**DESERT TORTOISE COUNCIL**

13 February 2025

RE: Purple Sage Energy Center Draft Environmental Impact Statement and Draft Resource Management Plan Amendment (DOI-BLM-NV-S010-2022-0094-EIS)

Figure 2. Locations of existing and proposed energy corridors in the Pahrump Valley, Clark and Nye counties, Nevada.

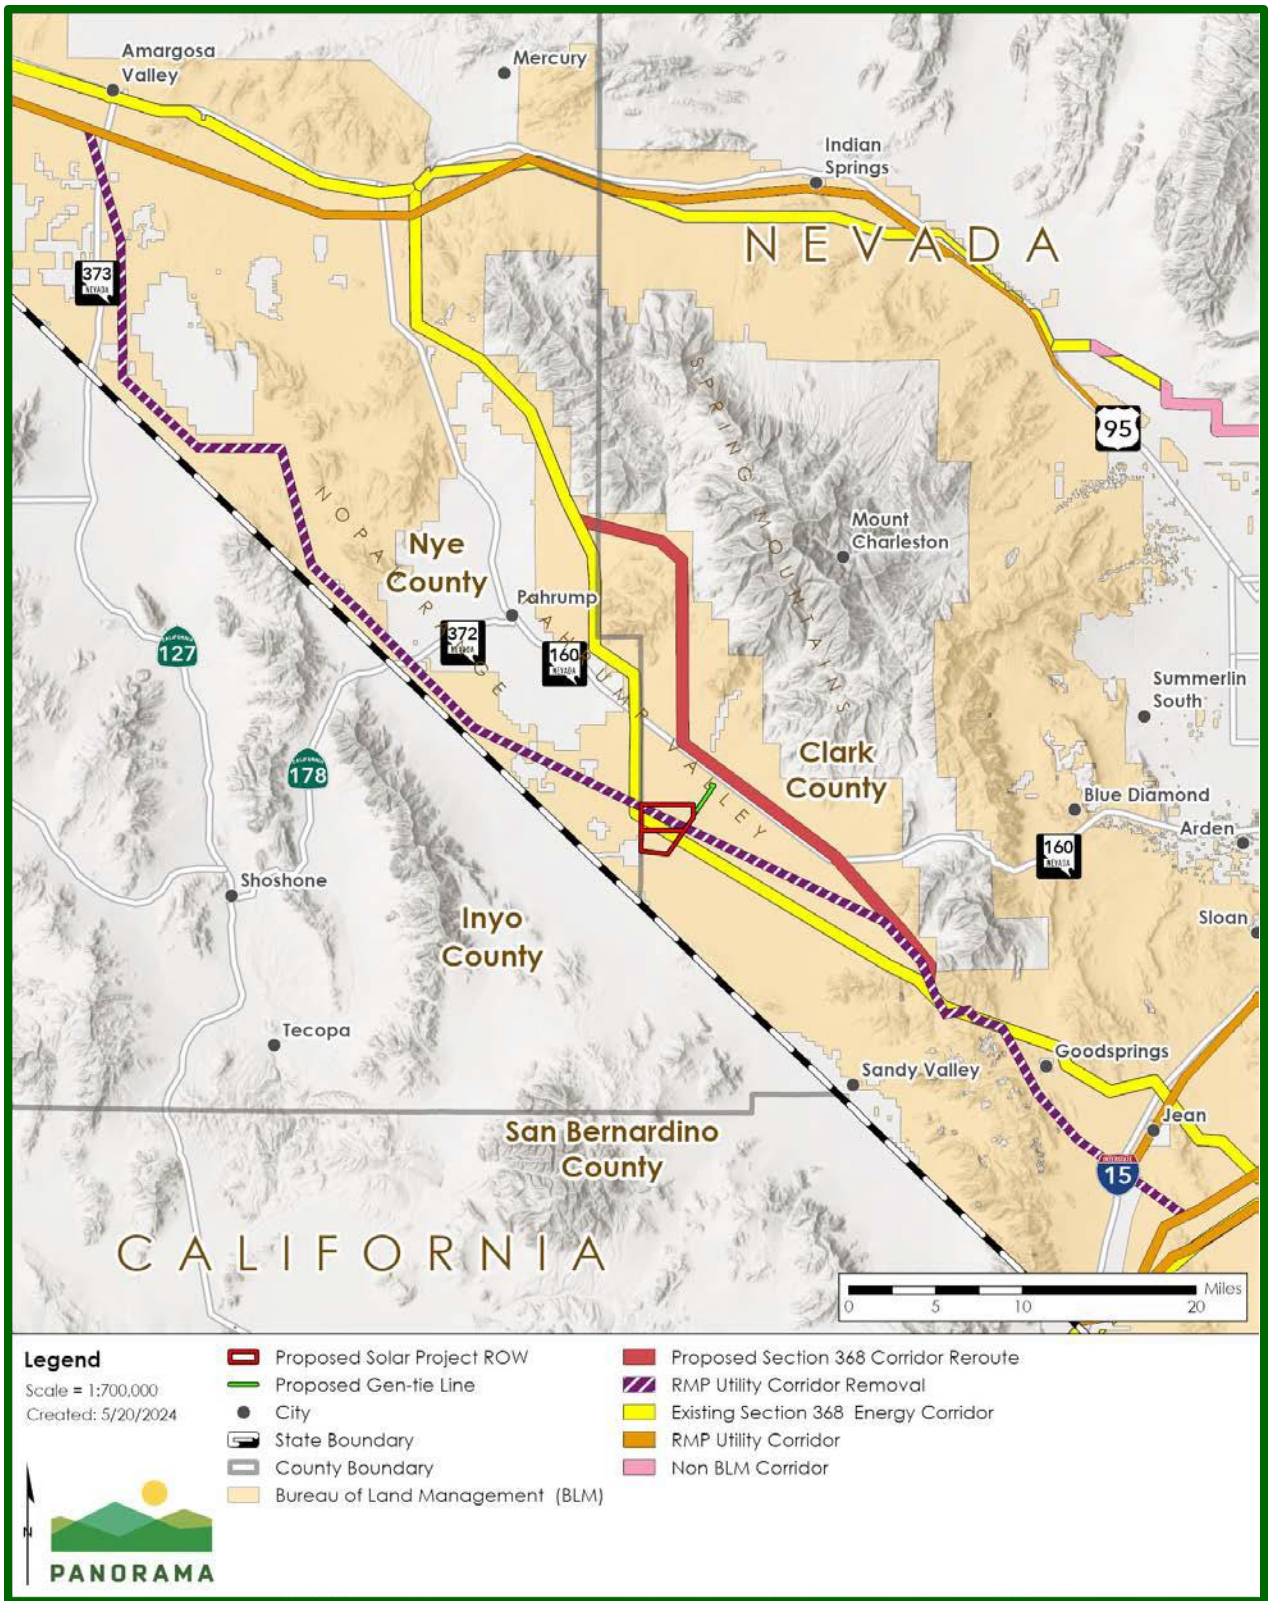
In addition, the project would require an amendment to the 1998 Las Vegas Resource Management Plan (1998 Las Vegas RMP) to modify two existing undeveloped utility corridors that intersect the project ROW (please see Figure 2).

Figure 3. Locations of major and minor drainages that would be affected by the footprint of Purple Sage Energy Center solar project.

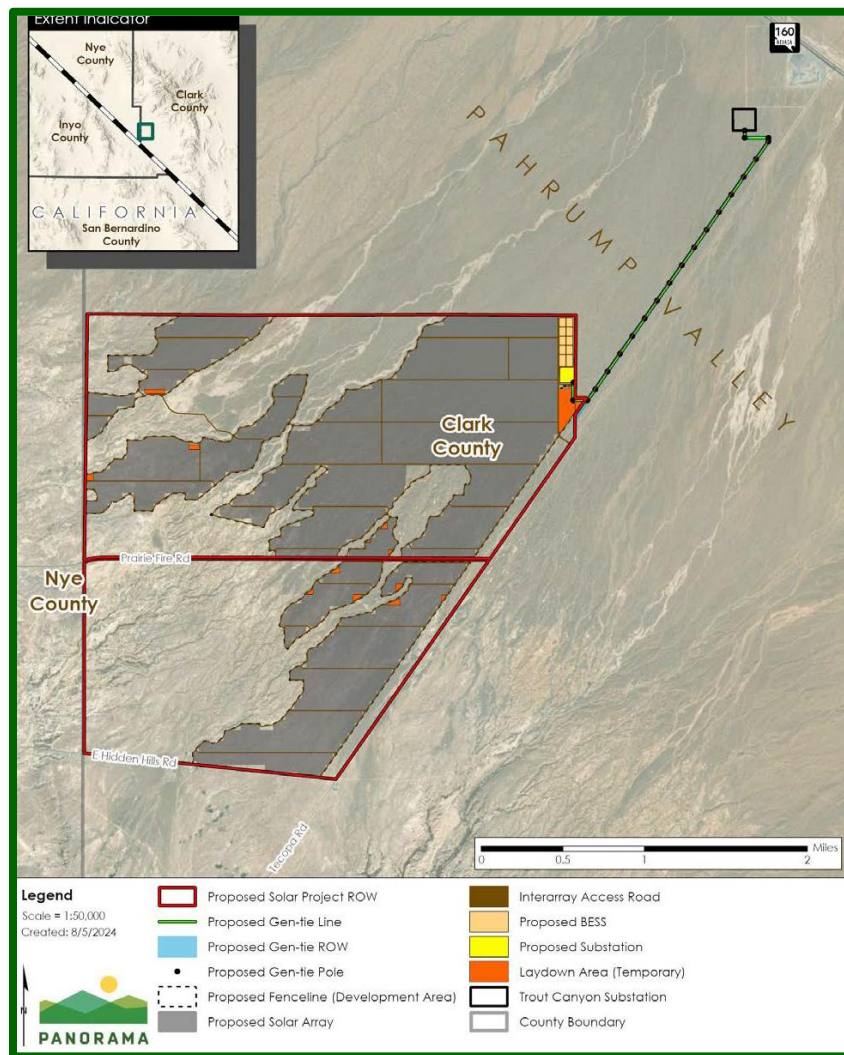
Roads and Access: BLM states that, “[c]oncrete causeways would be used in the large, incised washes that flow through the areas with sandy natural soils to protect the road in case of large storm events.” We are unclear about how and where these concrete causeways would be constructed and maintained. From our experience with causeways, if placed across washes, they would impede the flow of surface water and impede/prevent wildlife movement, especially for tortoises. If placed parallel to a wash they would remove important vegetation along the wash bank. Either design would result in adverse impacts to the habitats of wildlife species as well as vegetation in the causeway’s footprints and much farther down gradient.

BLM provides a map of where the solar facilities would be located. Many would be located where small washes currently occur (Figure 3). BLM should analyze the impacts to surface hydrology both on the project site and off-site and its resulting impacts on soil moisture and vegetation. We did not find this analysis in the DEIS. Devitt et al. (2022) reported that “[c]onstruction of roads, transmission lines and utility scale solar photovoltaic facilities can decouple up-gradient washes from down-gradient locations.” They reported that the decoupling of the wash system at a solar site “led to a significant decline in soil moisture, canopy level NDVI [normalized difference vegetation index] values and mid-day leaf xylem water potentials.” Over time, especially combined with climate change, this impact may result in reduced plant reproduction, growth, and survival for plants down-gradient of the decoupling sites including plants not on the project site.

BLM should require the Applicant to fund studies of surface flow during the construction, operations and maintenance, and decommissioning phases of the project to determine the geographic extent of the impacts of surface gradient disruption/decoupling both on-site and off-site and their impacts to the biological components of soils and vegetation. This analysis should include how the changes in surface gradients would impact wildlife, especially the availability of forage required for adequate nutrition and cover from predators and temperature extremes for all age classes of the tortoise down-gradient from the project site.

Figure 5. Adjacent Cumulative Solar Projects' Known Avoidance Areas in the Pahrump Valley – Purple Sage and two other solar energy projects, Clark and Nye Counties, NV.

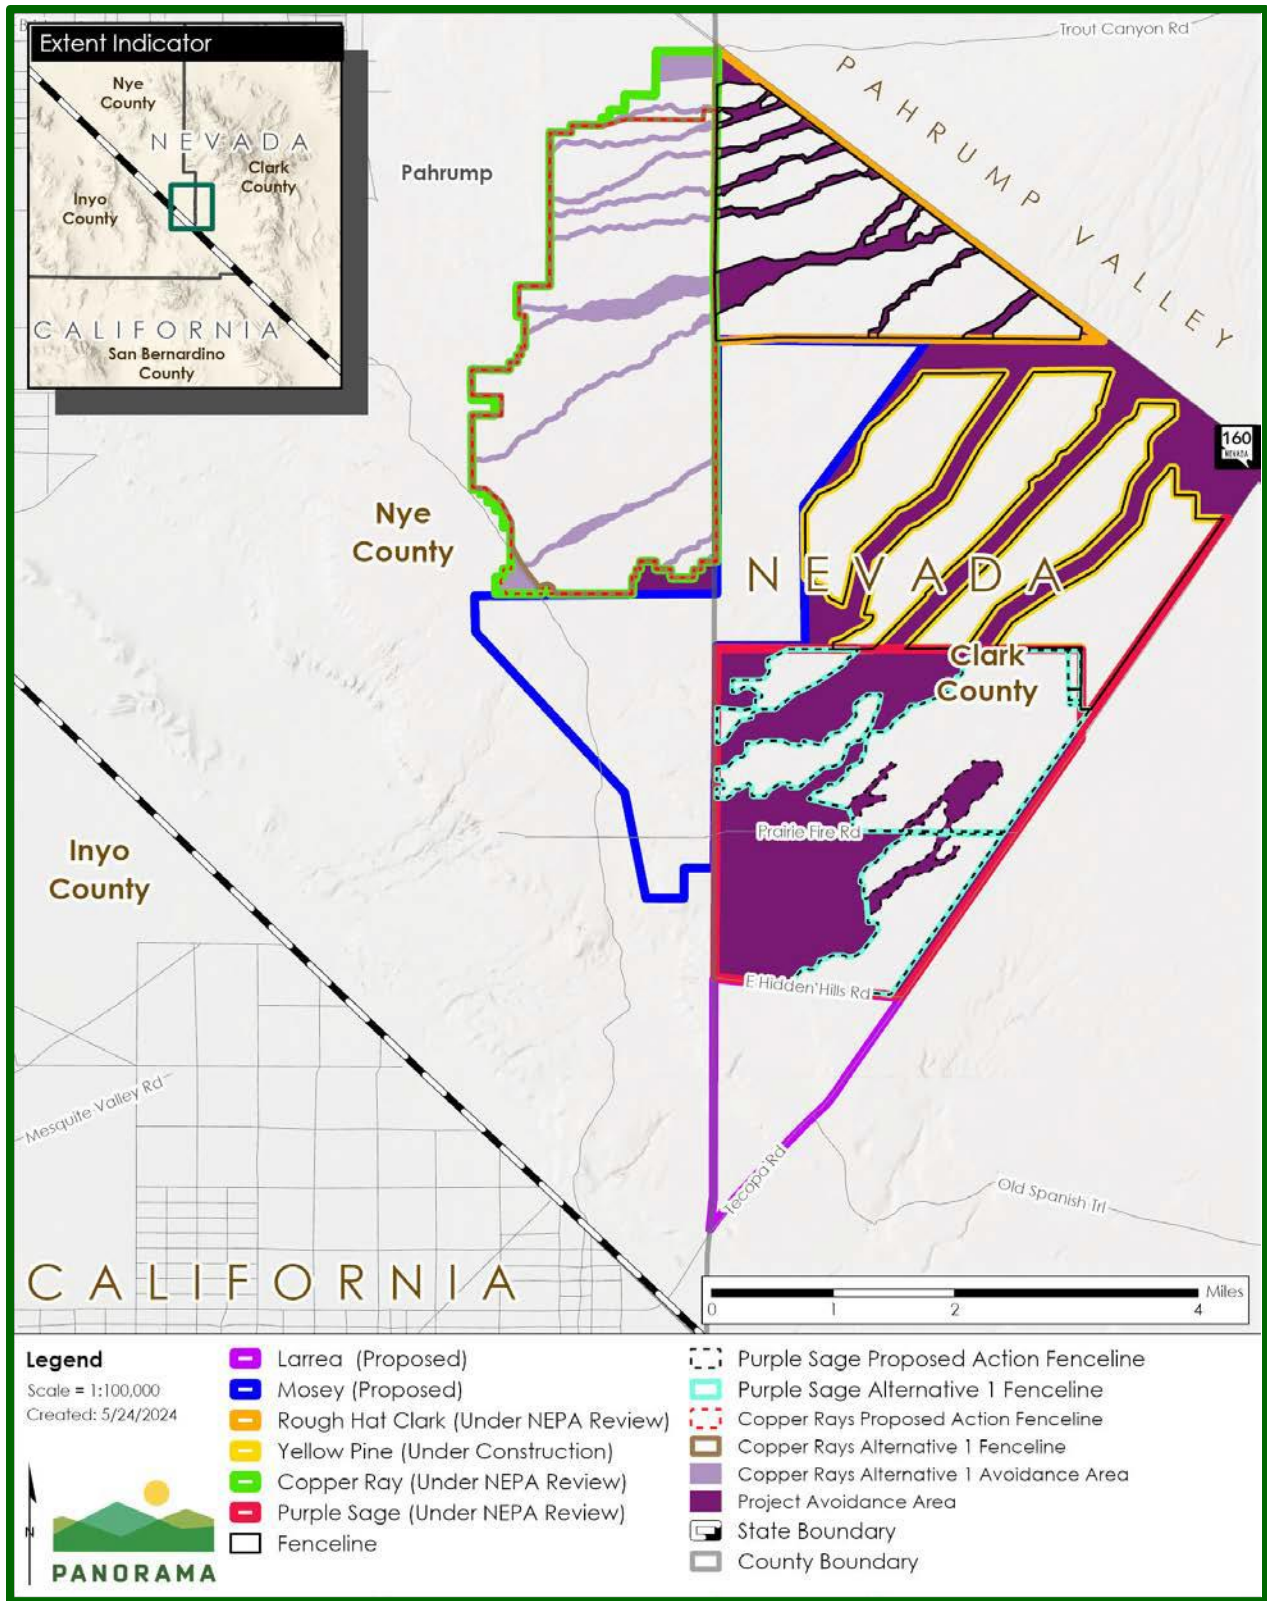
Avoidance Areas: BLM provided a map of areas the utility-scale solar projects in the Pahrump Valley are avoiding during construction, operations and maintenance (Figure 5). As demonstrated by the locations of the avoidance areas and the scale of the map, these avoidance areas would provide little to no benefit to the tortoise for providing movement between populations and in response to climate change. This conclusion is based on recent [post BLM & DOE Solar PEIS (2012)] research. We refer BLM to our information provide above under “Use of Outdated NEPA Documents and Selected Information” and “Relying on an Outdated Resource Management Plan.” For example, the information provided above shows that the “habitat linkages among TCAs must be *wide enough* [emphasis added] to sustain multiple home ranges or local clusters of resident tortoises (Beier and others, 2008; Morafka, 1994), while accounting for edge effects, in order to sustain regional tortoise populations.”

These BLM avoidance areas would provide little to no benefit to the tortoise as linkage habitat. Thus, we conclude that these avoidance areas would not provide mitigation for the loss of tortoise habitat until well after the project had been decommissioned and restoration effectively implemented to return the current ecological functions and values to the project site. This restoration would take decades if not longer (Abella 2010).

Figure 6. Purple Sage Energy Center Project Desert Tortoise Burrow Map.

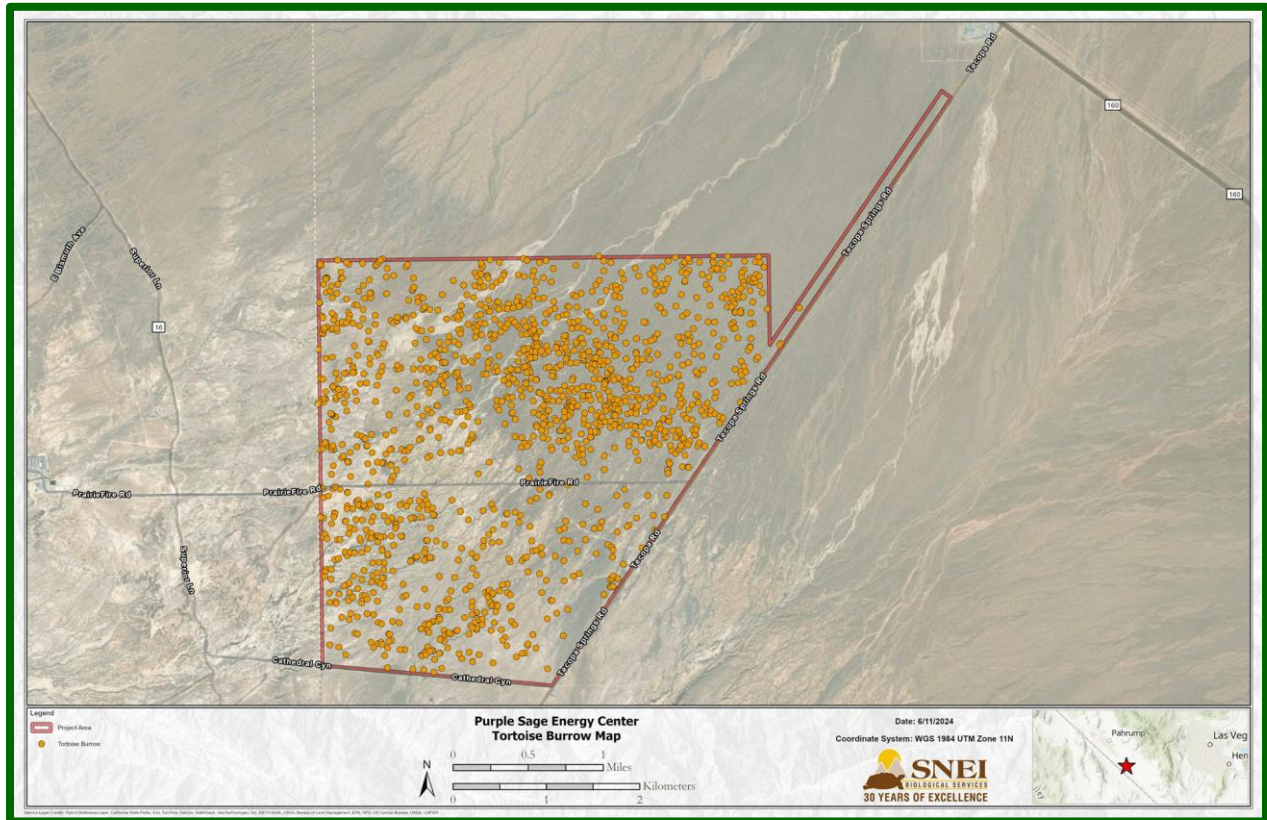
According to information provided in this appendix, more than 900 Class 1, 2, and 3 burrows were located on the project site (Figure 6).

The Council has several questions with respect to this information. First, the USFWS’s protocol calls for the “action area” to be surveyed. However, the information this appendix indicates the results for surveying only the project site. The “action area” is defined in 50 CFR 402.2 and the USFWS Desert Tortoise Field Manual (USFWS 2009) as “all areas to be affected directly or indirectly by proposed development and not merely the immediate area involved in the action area” (50 CFR 402.02). Thus, the action area where this 100% coverage survey should have occurred is larger than the project footprint/project site. Please revise the information in this appendix to include the results of conducting USFWS protocol level surveys for tortoises/tortoise sign for the action area including the areas impacted down-gradient from the project site by the disruption of surface hydrology (affecting the survival and availability of vegetation) and the heat island effect.

Second, we are unclear how the Applicant would effectively avoid the 900+ tortoise burrows on the project site during solar array block construction. Most solar arrays are located in the up-gradient/northeastern part of the project site which is where the majority of the tortoise burrows are located (Figure 6). During construction, it seems unlikely that most of these burrows would be avoided. If we are correct in this conclusion, then BLM should revise the information in the DEIS and state that most of the tortoise burrows would be destroyed during the construction phase.

Third, BLM’s mitigation measure to retain tortoise burrows indicates that BLM intends for the tortoise to reuse the project site following completion of the construction phase. As mentioned earlier in our comments on page 2-12, “Wildlife Access,” we found conflicting information in the DEIS on whether reoccupation of the project site by the tortoise would or would not occur.
